MASSIE CONSTRUCTION & LAND MANAGEMENT'S PROPOSAL FOR THE COUNSELOR'S CLOSE PROPOSED DRAINAGE & SITE IMPROVEMENTS FOR 612, 616, 618, 620, 624, 638, 640, & 642 COUNSELORS WAY

Ref: Massie Construction & Land Management LLC Proposal for Counselor's Close Drainage & Site Improvements 612,616, 618, 620, 624, 638, 640, & 642 Counselors Way

We have provided our responses to each of the questions received from Massie Construction & Land Management dated 4-9-2024 in red below. We have also attached our revised Construction Drawings clarifying the Contractors Questions.

LANDSCAPE WALL

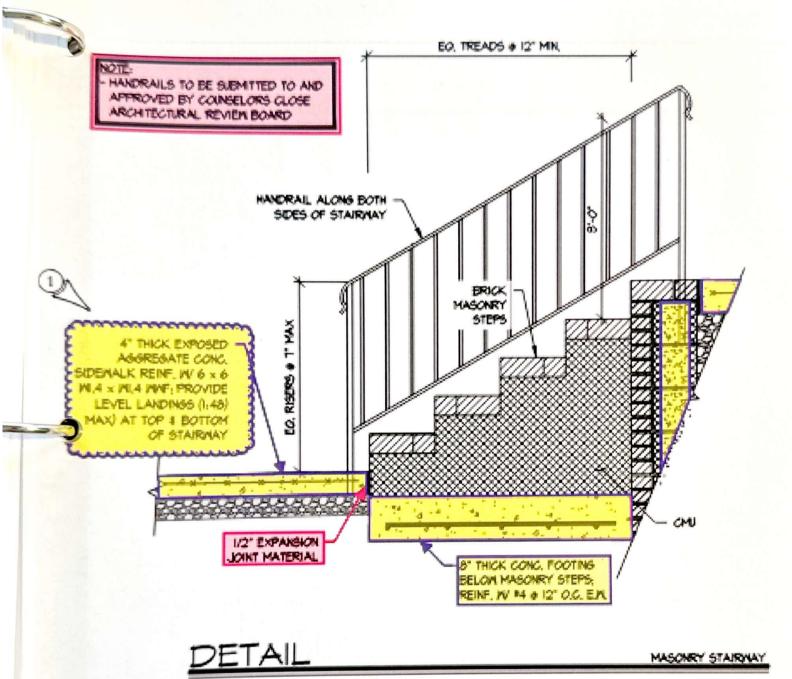
2.) On page 7 of 7 on detail A-56 of the retaining wall detail shows using compacted backfill behind a cinder block masonry wall. Also, under the general notes on page 7 of 7 note number 5 says that bracing may be required to resist soil pressure and other loads during construction. Massie Construction and Land Management would like to recommend an alternative to the compacted fill behind the wall that will be less of a risk to the project. Once the wall is placed, we would like to recommend placing 57 stone as fill to complete the fill in its entirety. This will cause the least amount of pressure against the wall and there will be very little to no compaction required for this material compared to dirt back fill. This will eliminate the need for bracing and or any structural damage to the new wall structure. If this is acceptable to owner, we will base our proposal on this process. Please see the drawing and note below. The red shade area is where we would like to place the 57 stone for backfill.

TSG Response: The substitution of No. 57 stone in lieu of compacted fill is permissible. If No. 57 stone is utilized, we recommend the entirety of the No. 57 backfill be fully wrapped with filter cloth. Utilizing this alternate method, the fully warped No. 57 backfill would serve as the chimney drain.

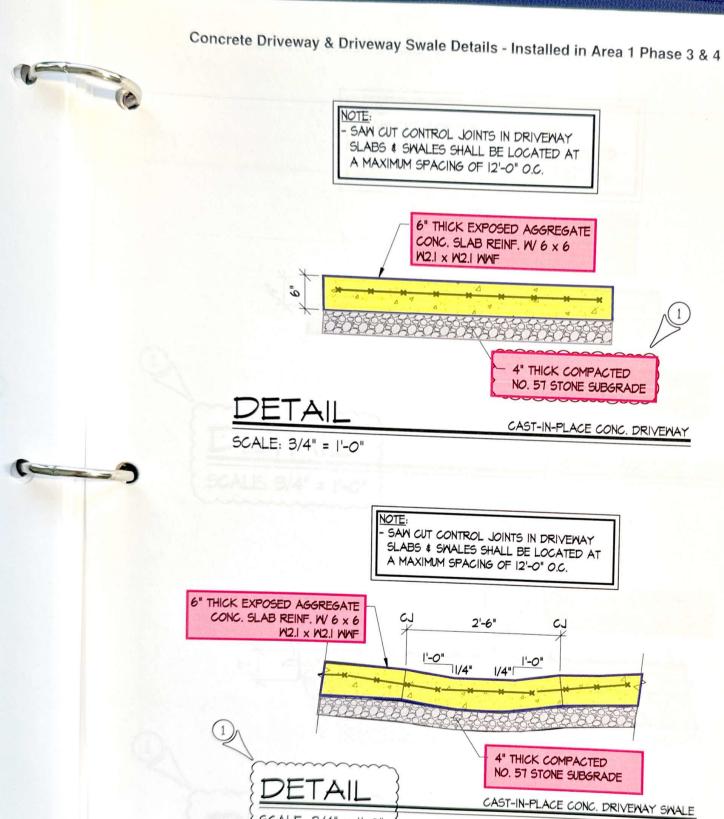
24. In the detail below the Drain Chimney detail shows the drain tile pipe being higher than the bottom of the 57 stone chimney by quite a bit. If this drain tile is this high how does the water get out of the 57 stone that sits below the drain tile. This water will just be sitting behind the wall with no way out. Either the drain tile needs to be lowered or the chimney needs to be raised. Typically, the 57 stone goes all the way down to the top of the footing and the drain tile sits directly on the top of the footing. This puts the drain tile at the lowest point where it catches the water and pulls it out. Please see drawings below for further details:

TSG Response: While any moisture accumulation below the chimney drain is negligible to the design and offset by the passive soil pressure along the toe of the wall, the construction drawings have been revised to outlet the drainpipe to the adjacent 12" x 12" nyloplast catch basin.
